SUBDIVISION REPORT

S/D No. 81-67 Name J. W. Washington Addition
Date Application Rec'd. 6-24-81 Preliminary Approval _____
Scheduled S/D Meeting 7-9-81

Re: S/D 81-67 - Final plat of J. W. Washington Addition

PROJECT J. W. Washington Addition Revised

REFERENCE Drainage Plan

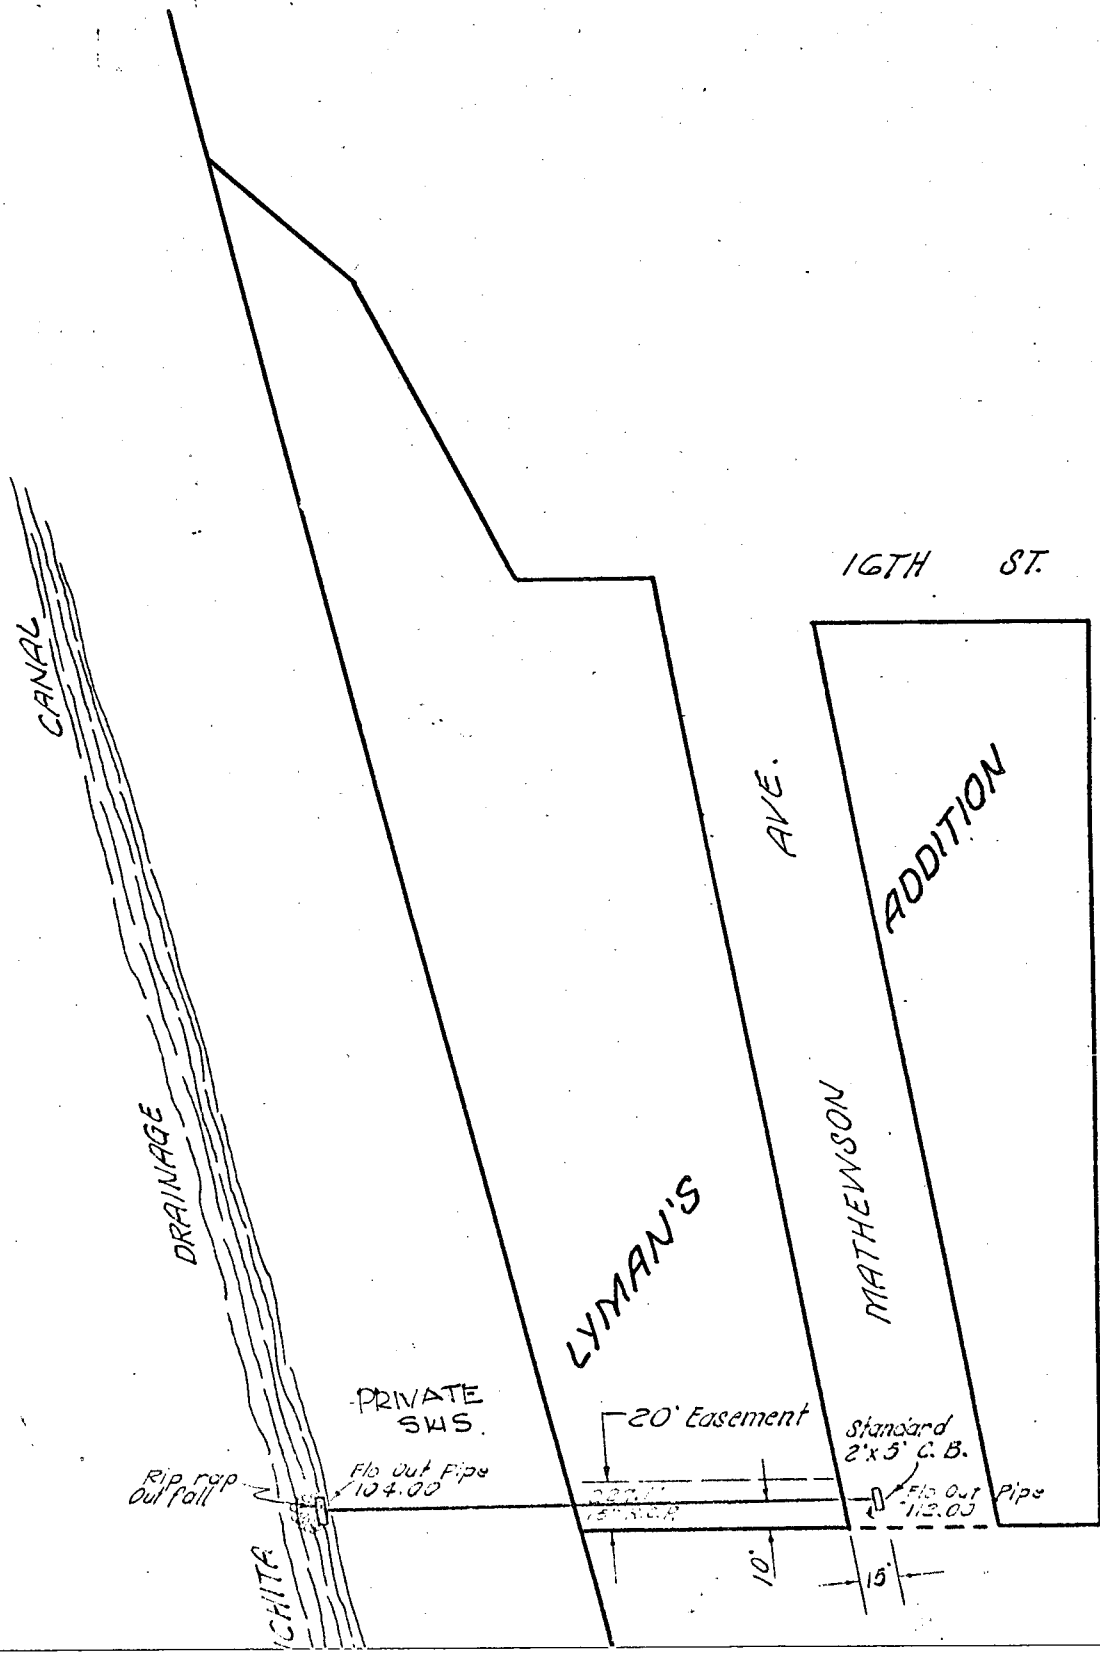
Presently a 15" RCP and an inlet exist along the south line of said plat which drain west into the canal. Approximately 2.5 acres drain to Mathewson and 16th Street intersection and south into this area.

The capacity of the existing pipe into the canal is around 14 CFS.

The 2-year storm runoff flo for this area would be =

$$Q = (0.50) (4.06) (2.5) = 5.1 \text{ CFS.}$$

A 15" pipe at 0.700% grade is proposed to extend from the existing inlet to the proposed inlets at the proposed cul-de-sac. Capacity in this pipe would be 5.4 CFS.

ON ADDITION

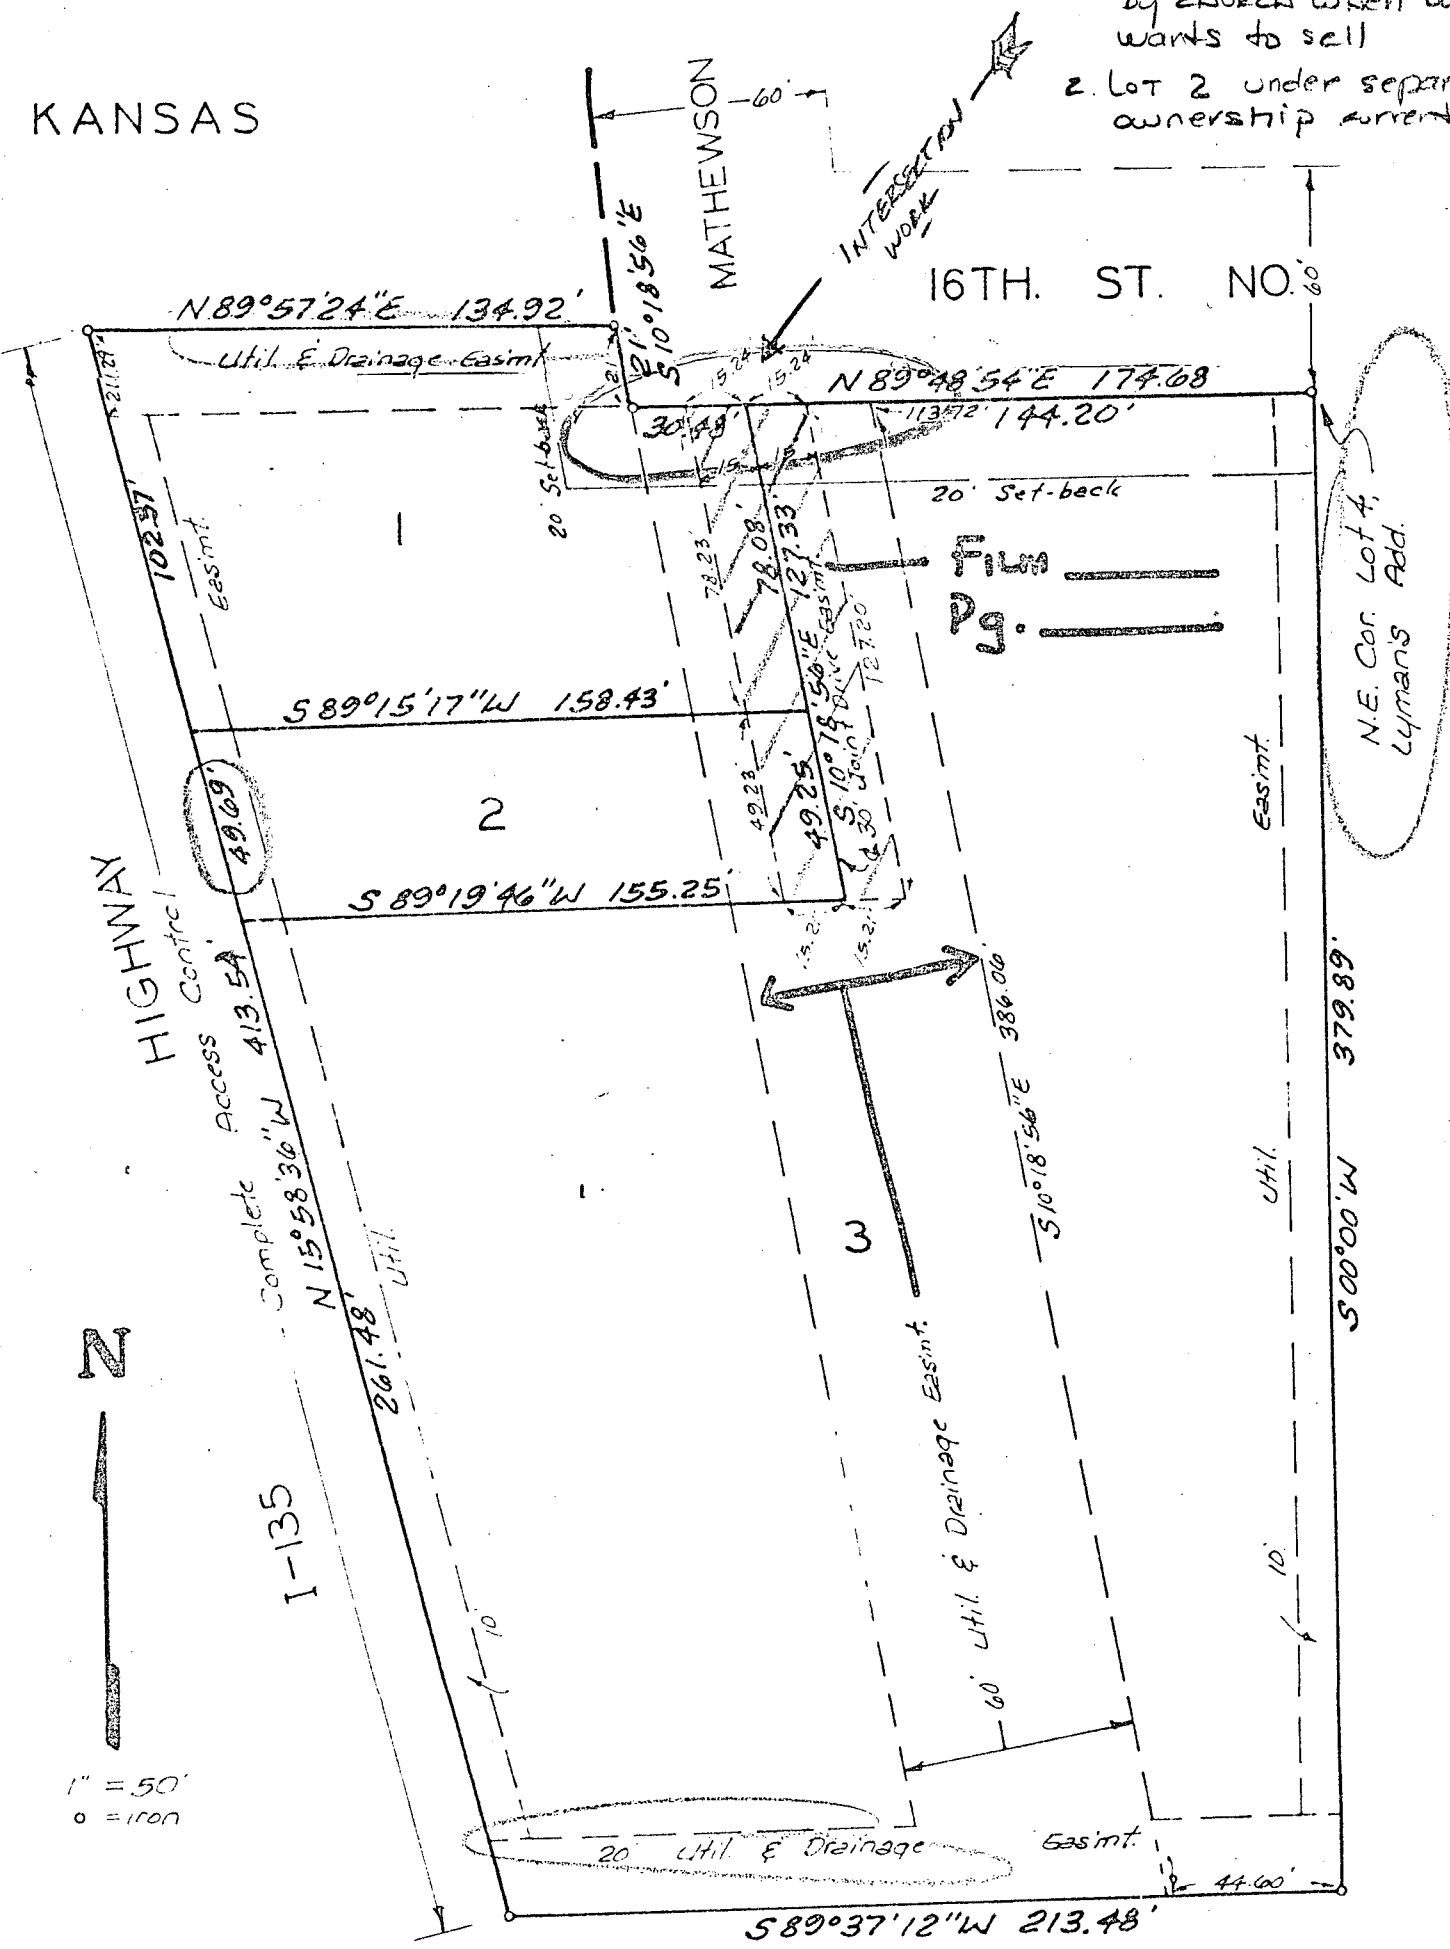
- CHECK OWNERSHIP**
ON ASSOC. BZA CASE
1. LOT 2 TO BE PURCHASED by CHURCH when owner wants to sell
 2. Lot 2 under separate ownership currently.
